August 8, 2012

**Re: Proponent is attempting to rewrite the Public Consultation history
of the
Proposed Hydro-electric Generating Station at the Bala Falls**

Mitchell Shnier, on behalf of SaveTheBalaFalls.com

Figure 1 – Option 1 as shown in July 5, 2005 proposal (property boundary and text added)

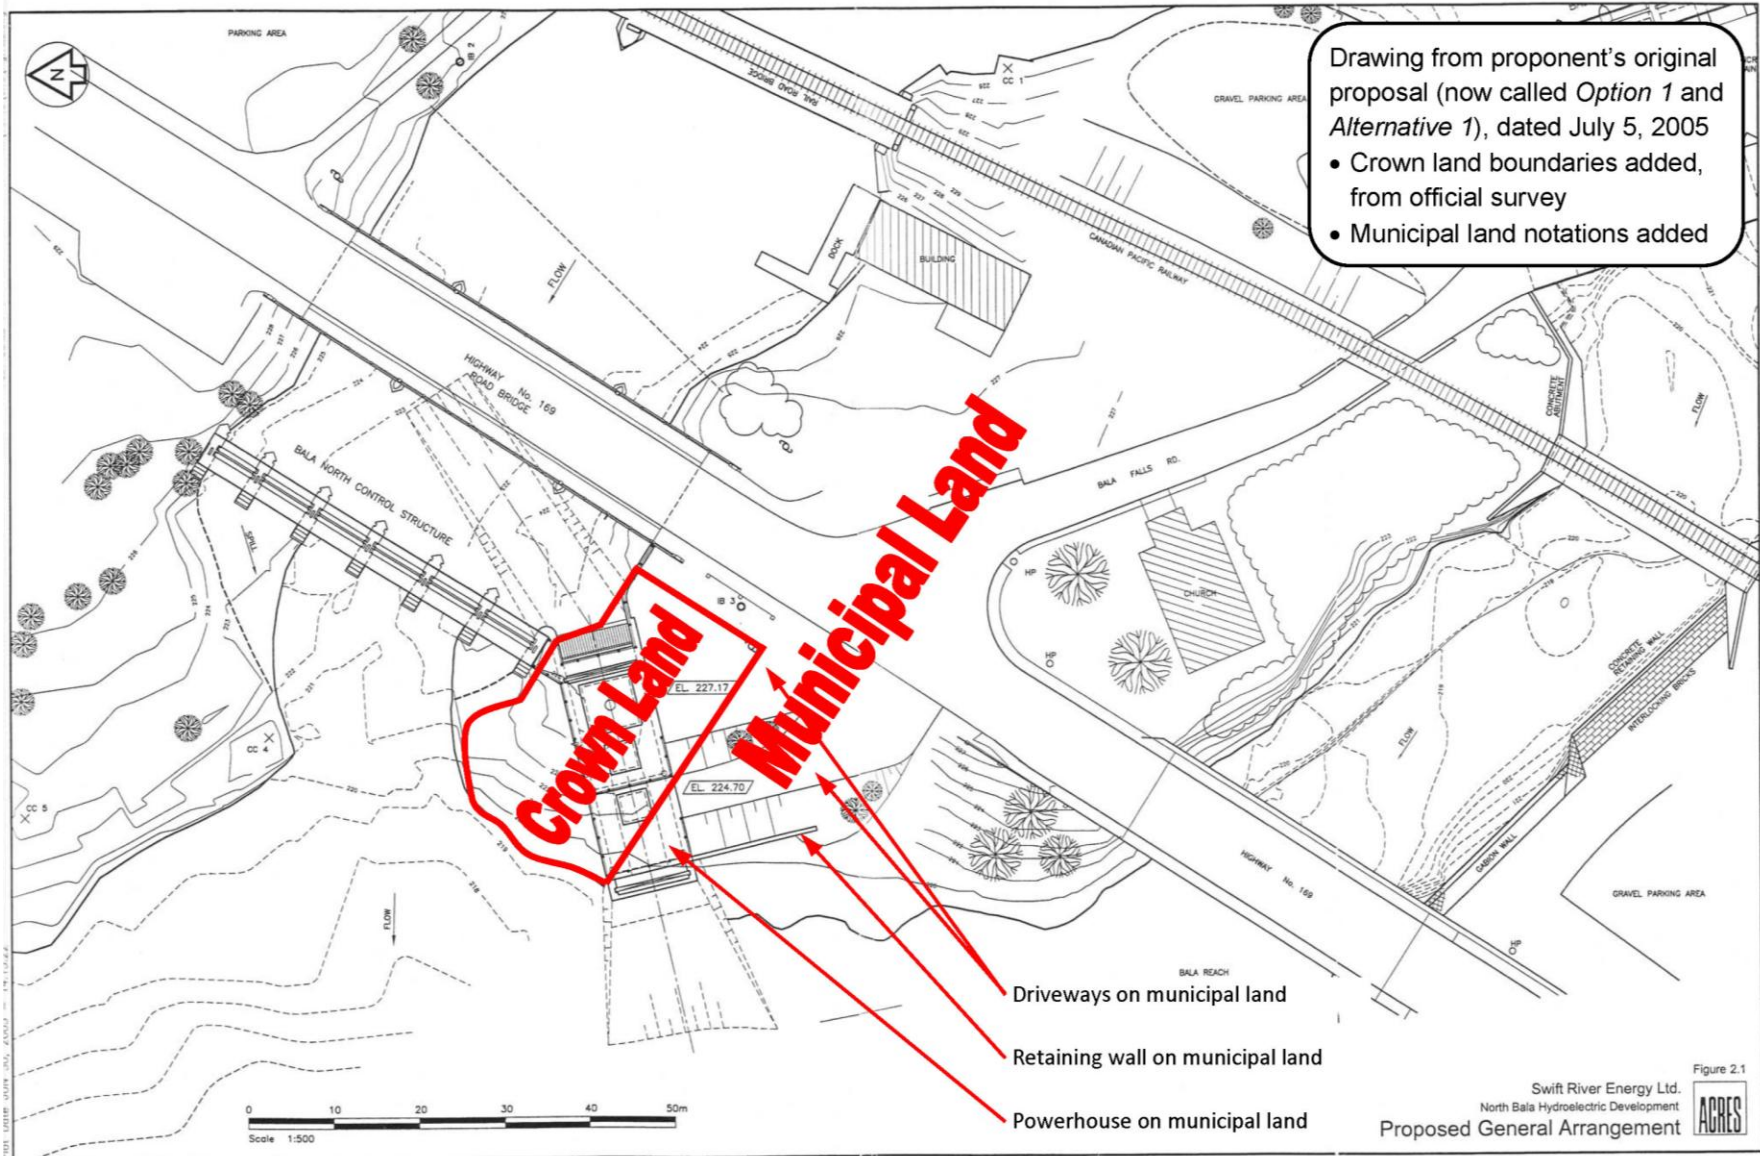
- a) The proponent’s first proposal was dated July 5, 2005, to the Ministry of Natural Resources, in response to the MNR’s Competitive Site Release program. Figure 2.1 from their proposal (with property boundary and comments added) is reproduced as Figure 1 of the Appendix to this letter.
- b) On August 29, 2007 the proponent held a public information centre, and the presentation material from this was provided in Appendix D5 of their environmental screening report. Page 8 of this Appendix D5 showed the plan view of their first proposal, and this (with property boundary and comments added) is reproduced as Figure 2 below.

The proponent has always referred to their Option 1 as requiring only Crown land, yet as we have shown in Figure 1, Figure 2, and Figure 3 below, **all the formal documents from the proponent have all shown that Option 1 could not be built solely on Crown land.** We have noted this confusion on our web site, in our e-Newsletters – and in public presentations to the District Municipality of Muskoka Council and the Township of Muskoka Lakes Council at which the proponent was present.

Figure 2 – Option 1 as shown at August 29, 2007 Public Information Centre (property boundary and text added)

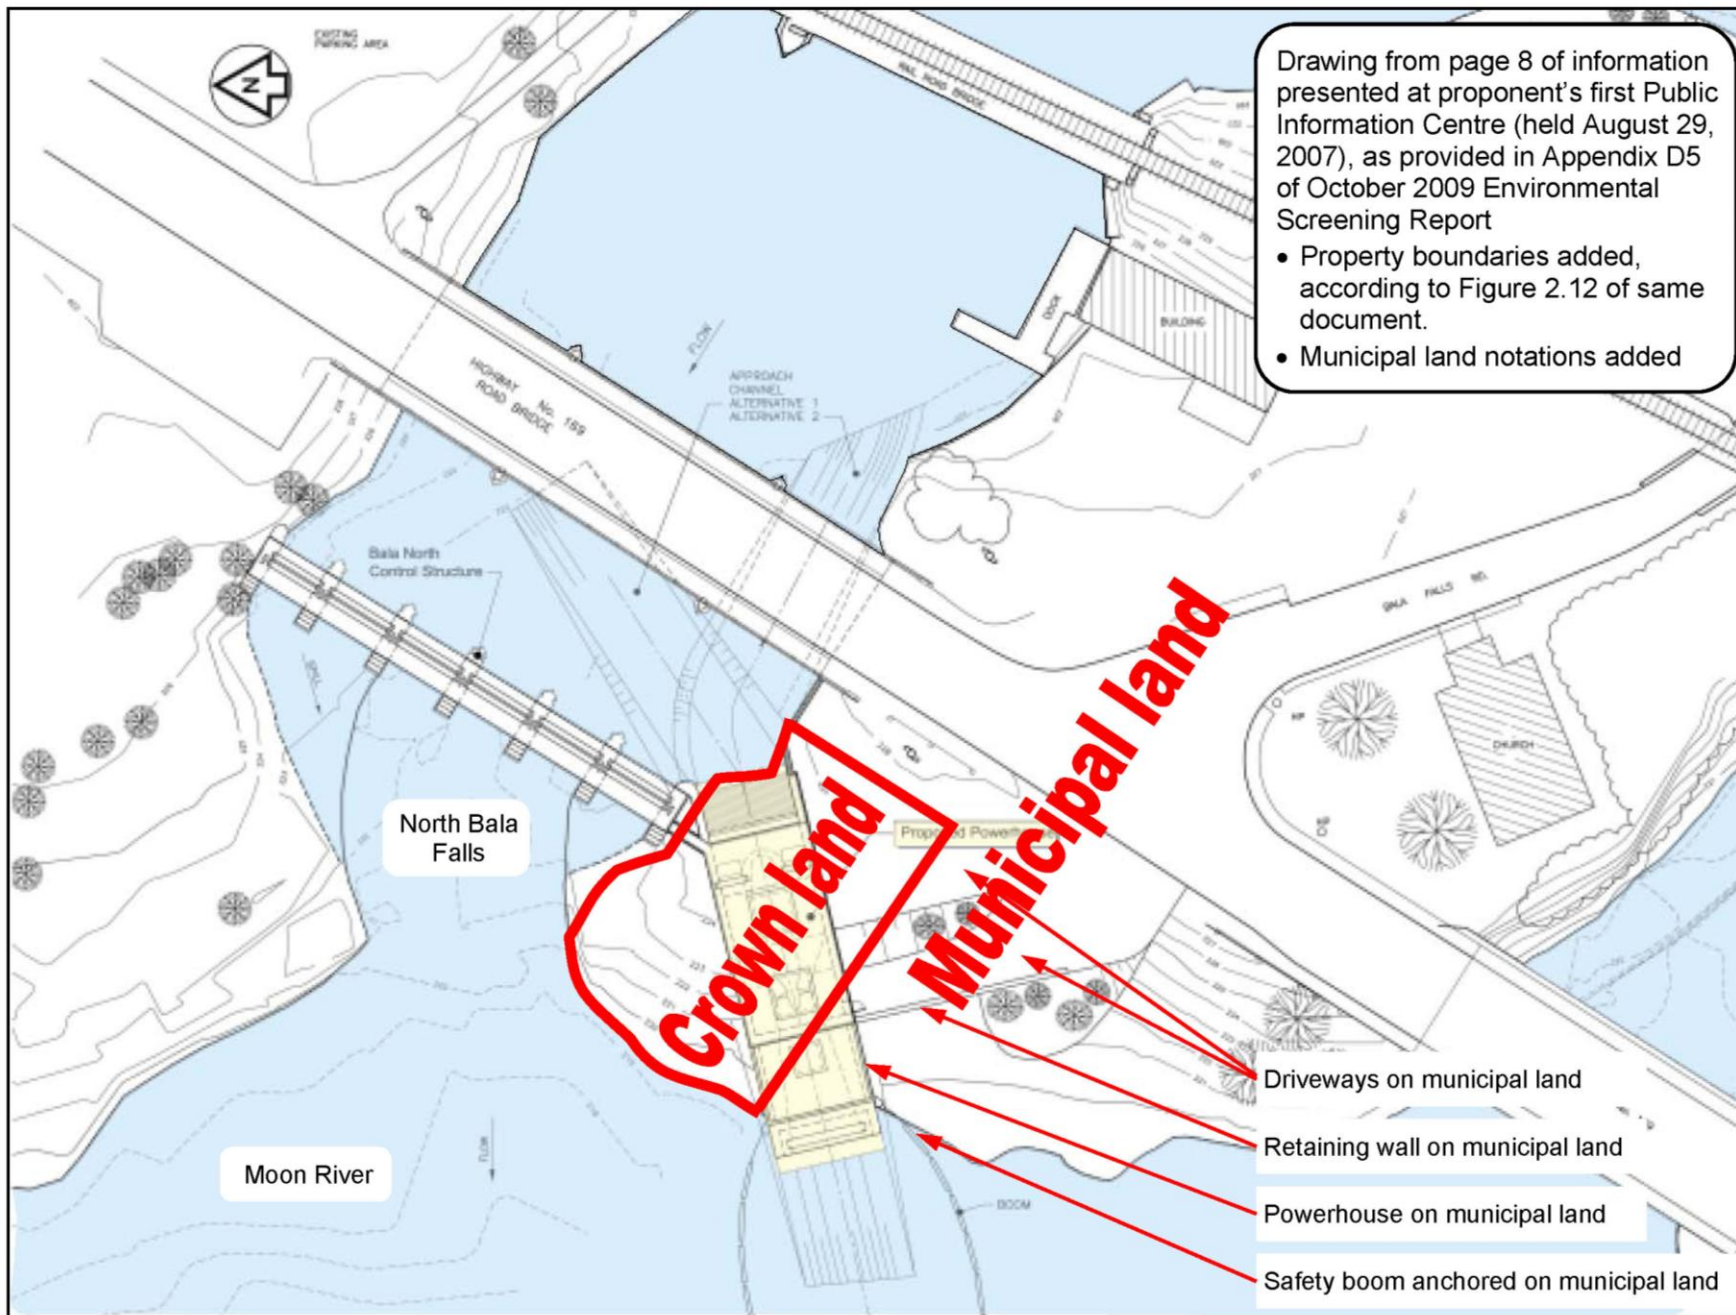
- Intake/Powerhouse both on west side of highway.
- No tunneling under road.
- Will still entail blasting and rock removal from site.

Figure 4 – Option 1, as shown as Layout Alternative 1 in Appendix A of October 2009 Environmental Screening Report

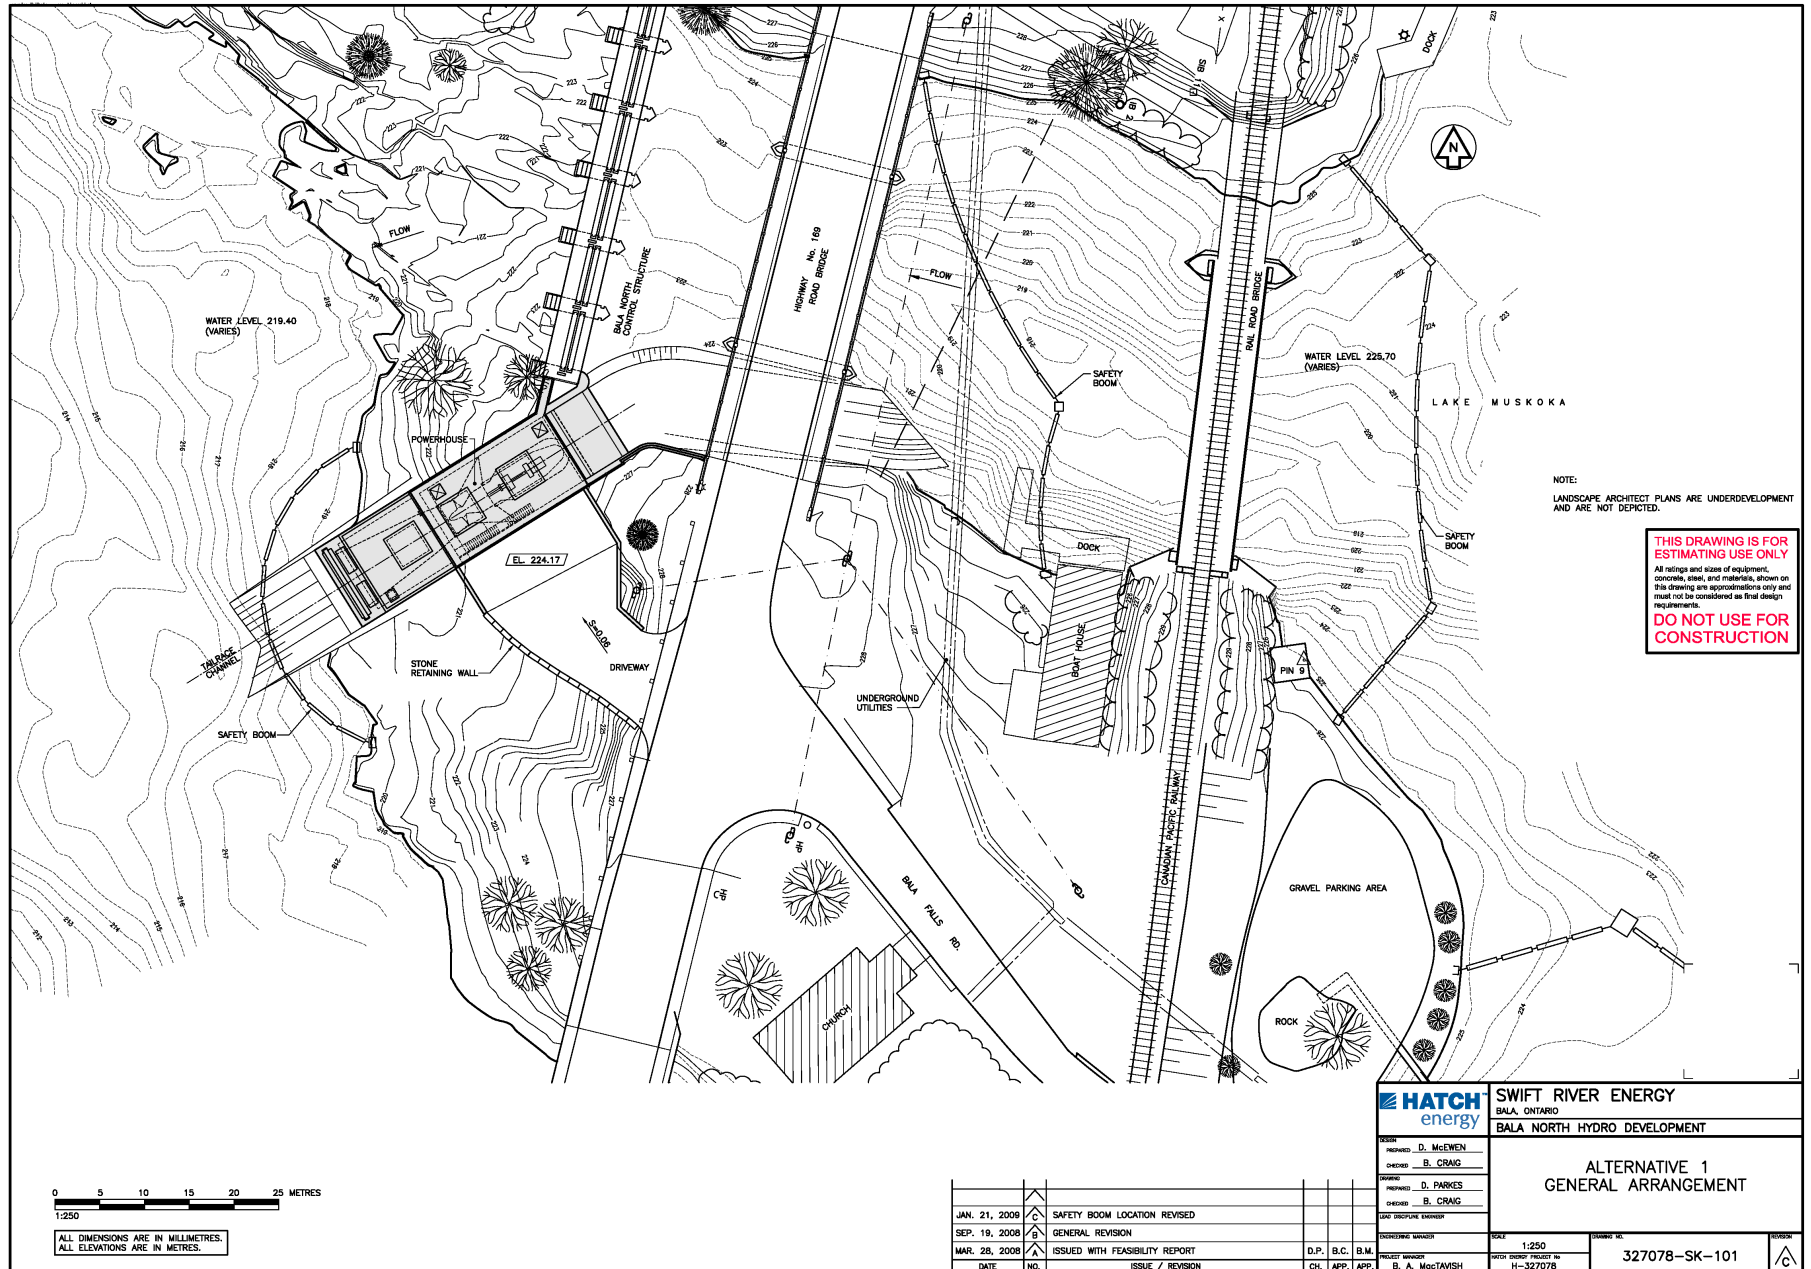
- c) Section 1.5.1.1, entitled *Layout Alternative 1*, of the proponent's environmental screening report, dated October 2009, states "*This original design (Drawing 327078-SK-101 in Appendix A2) was proposed as part of the as part of the site release program application ...*". This Section 1.5.1.1 also notes that "*Alternative 1 was presented during the Public Information Centre (PIC) of 2007*". This drawing is reproduced as Figure 4 below as provided in the environmental screening report, and as Figure 5 cropped and with property boundary lines and text added.
